Re: 300 Colorado Office – Downtown Density Bonus Program (“DDBP”) Application and Summary of Compliance with the City of Austin’s Urban Design Guidelines for an office tower located at 300 Colorado Street related to site development permit application case SP-2018-0096C.

Date: June 06, 2018  
To: City of Austin Design Commission  
From: Planning & Urban Design Working Group  
Subject: Working Group Density Bonus Program review of 300 Colorado Street for substantial compliance with the Urban Design Guidelines.  
Meeting Date: May 31, 2018; 12:00 pm, One Texas Center, Room 500  
Applicant: Amanda Swor - Drenner Group PC  
Architect: Pickard Chilton

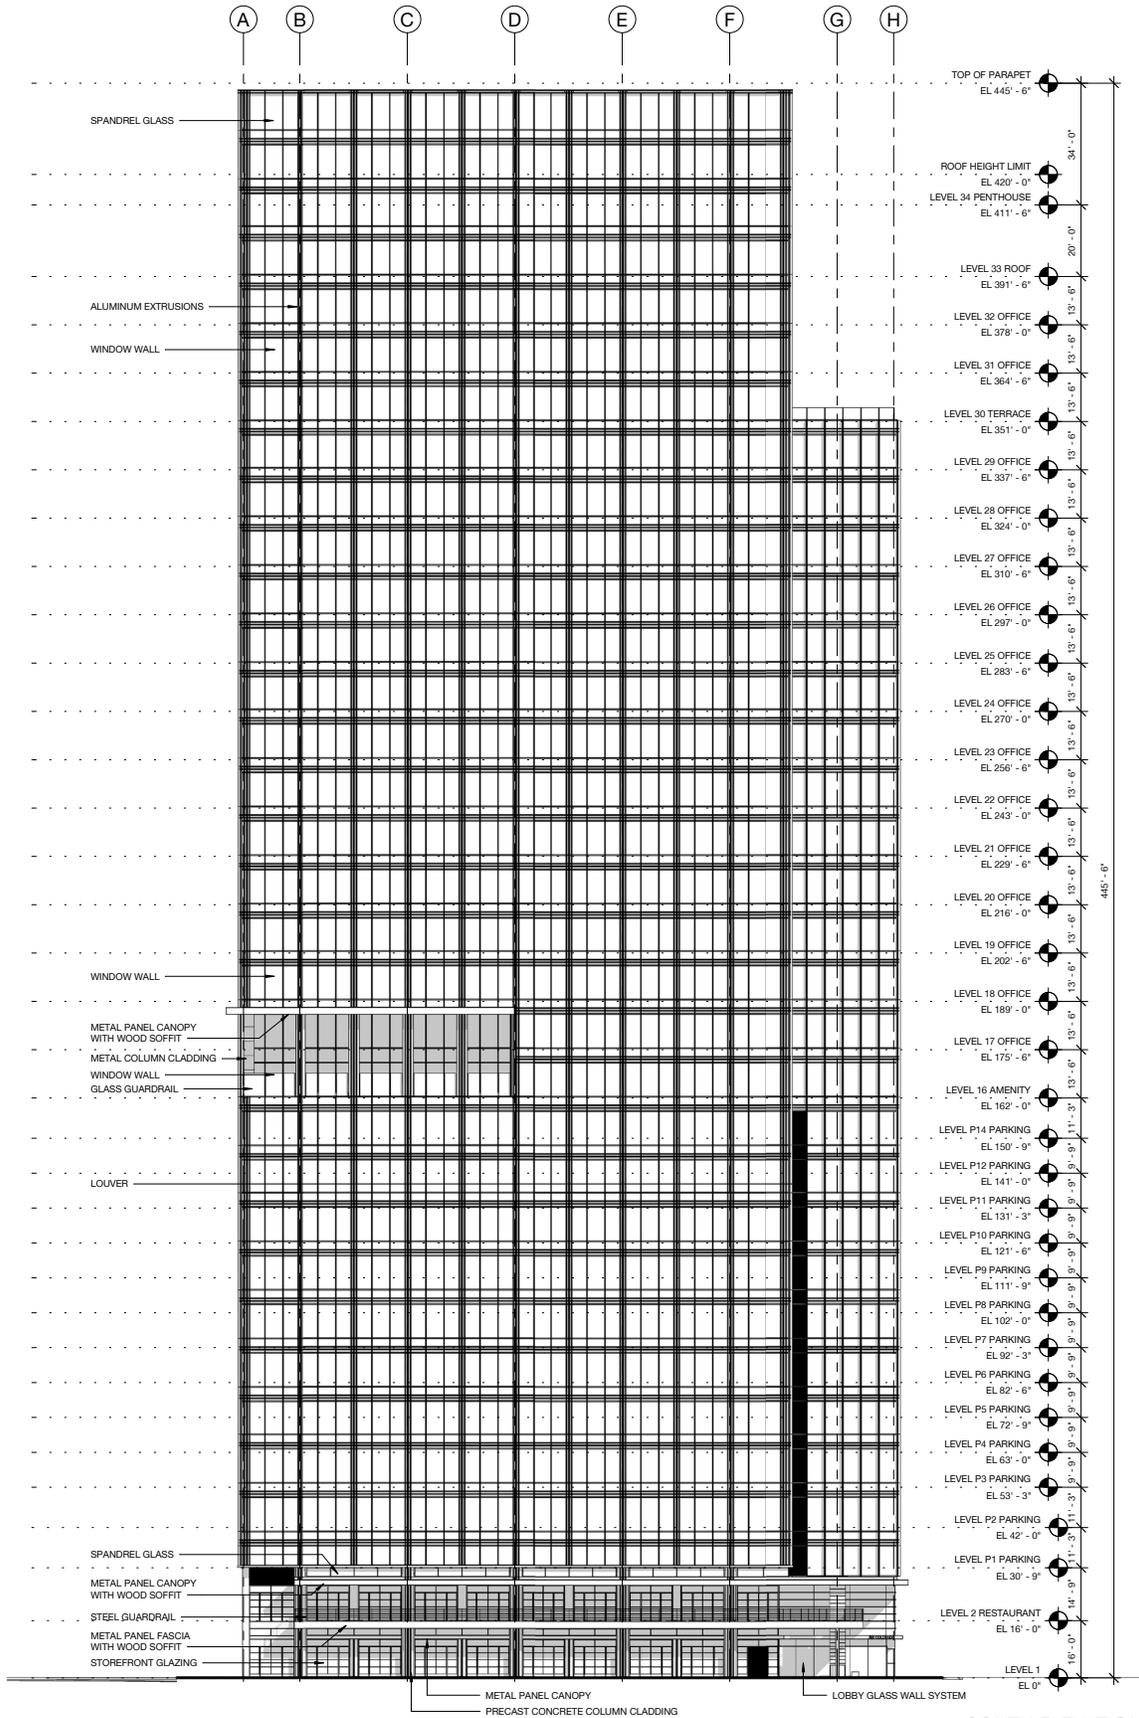
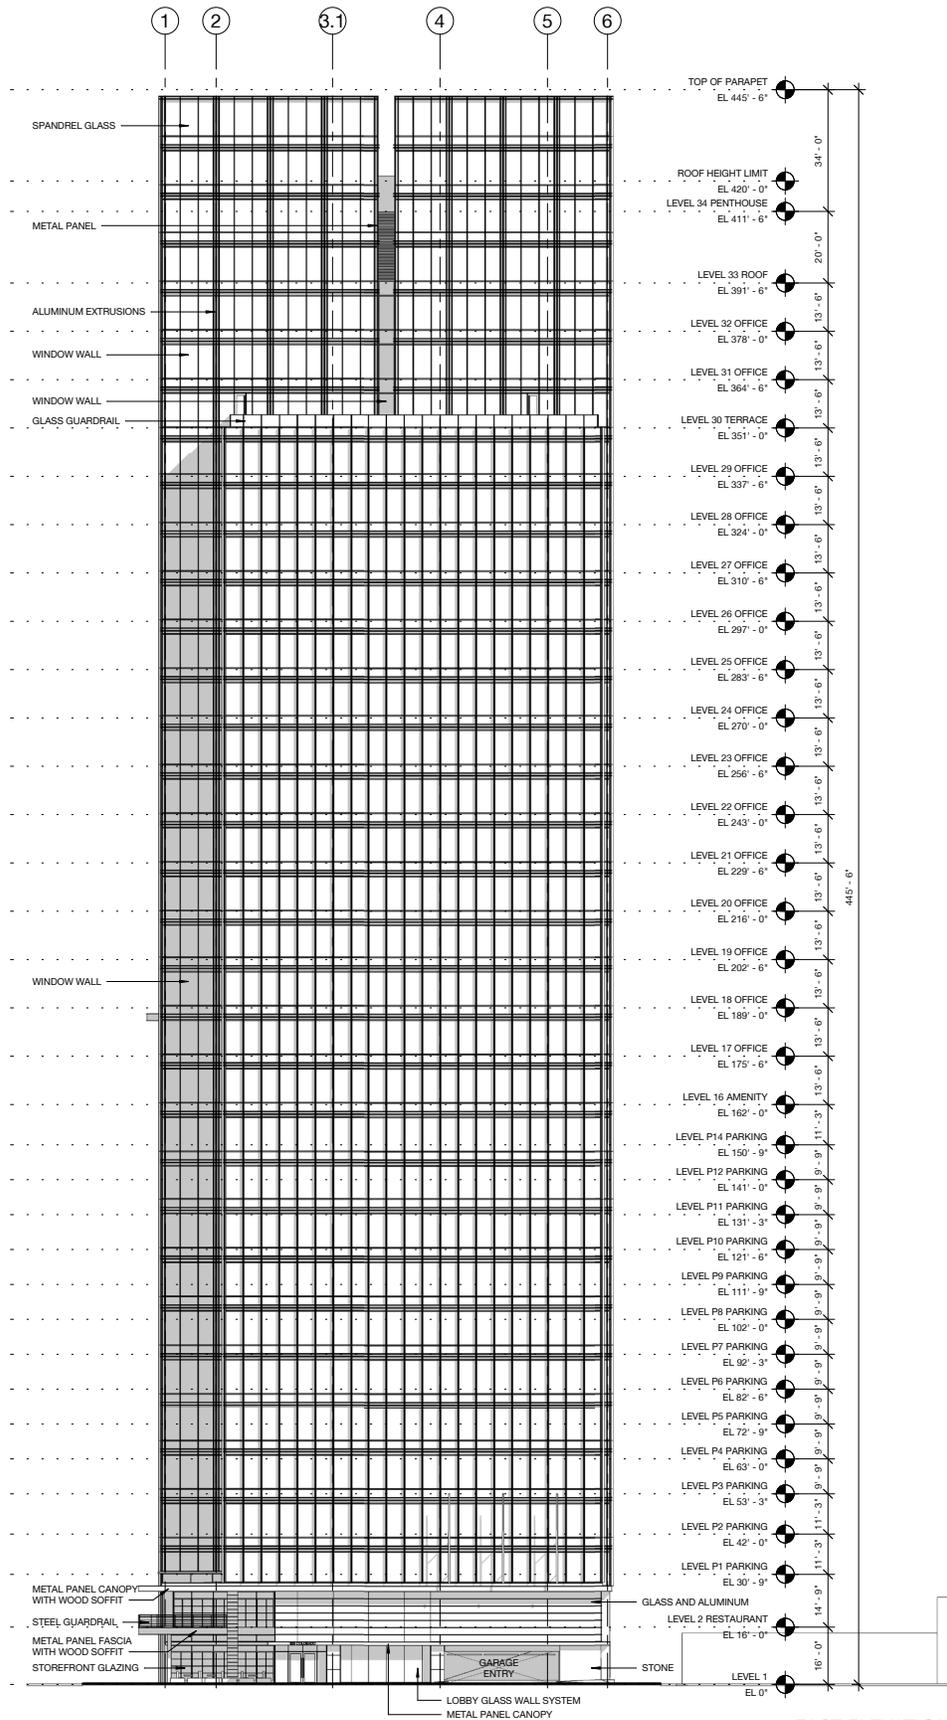
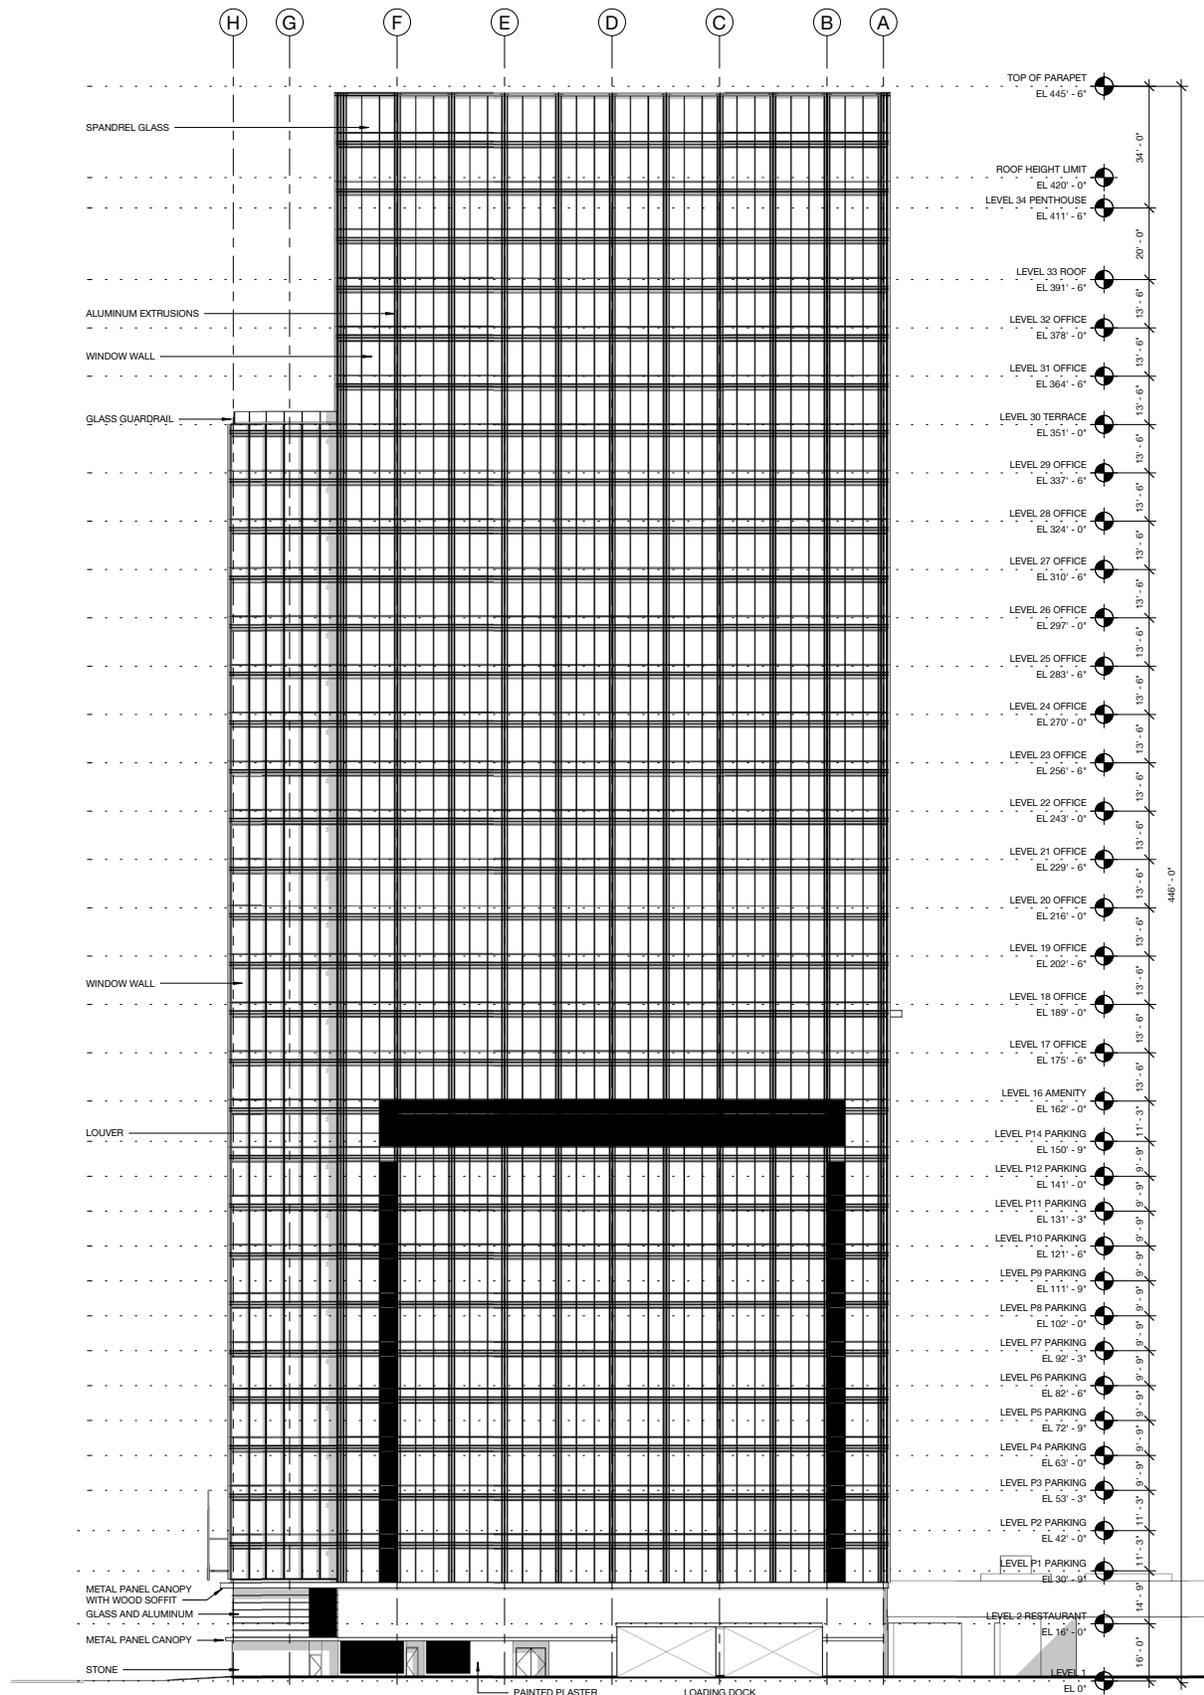
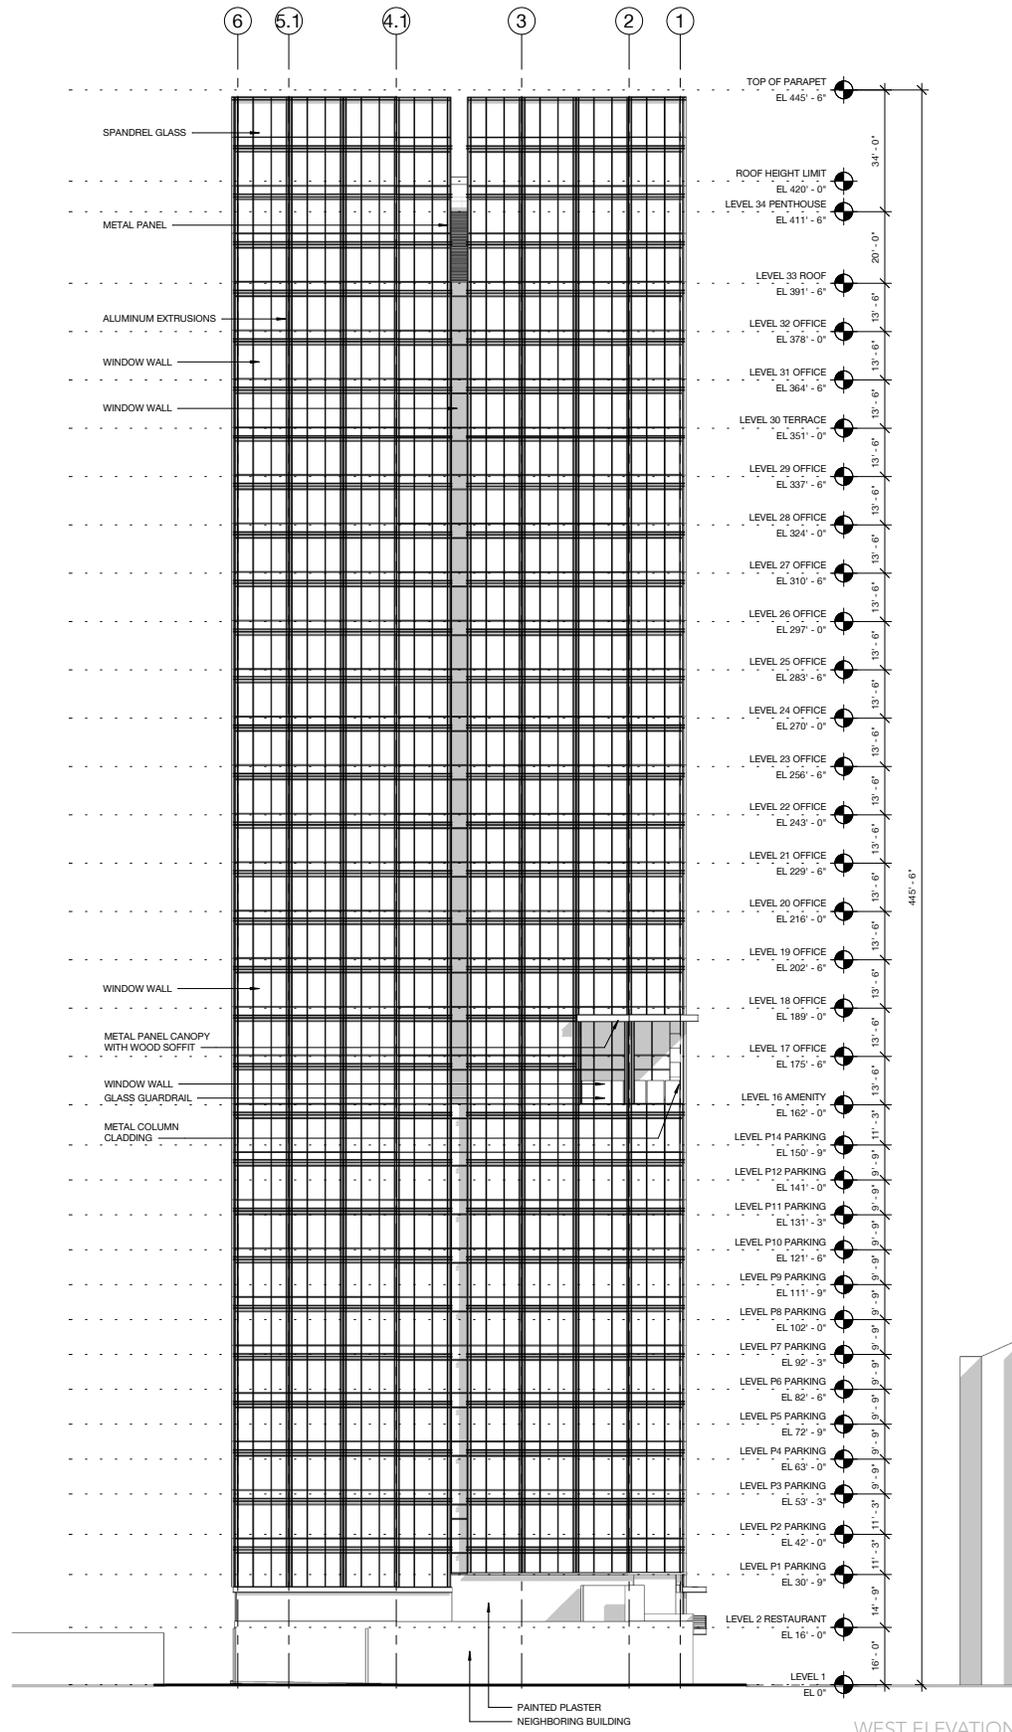
1. Protect the pedestrian where the building meets the street-  
Overhead protection does not appear to be at least 8 feet deep and not cover at garage entry. The project does not comply with this section. Increase depth of overhangs to comply with this section.

1. Build to the street-  
Plaza at 3<sup>rd</sup> & Colorado is setback, but rest of building is up to pedestrian zone. Project complies
2. Provide multi-tenant, pedestrian-oriented development at the street level-  
Project lacks pedestrian-oriented development as envisioned in UDG. Office use is not on street level-  
Project does not comply. Provide multiple street level uses to comply with this section.

3. Accentuate primary entrances-  
Building façade is glass box with no differentiation, or step back, for entrances. Project does not comply.
4. Encourage the inclusion of local character-  
The inclusion of local character is limited; the glazing system does little to reflecting Austin's character.  
Project minimally complies.
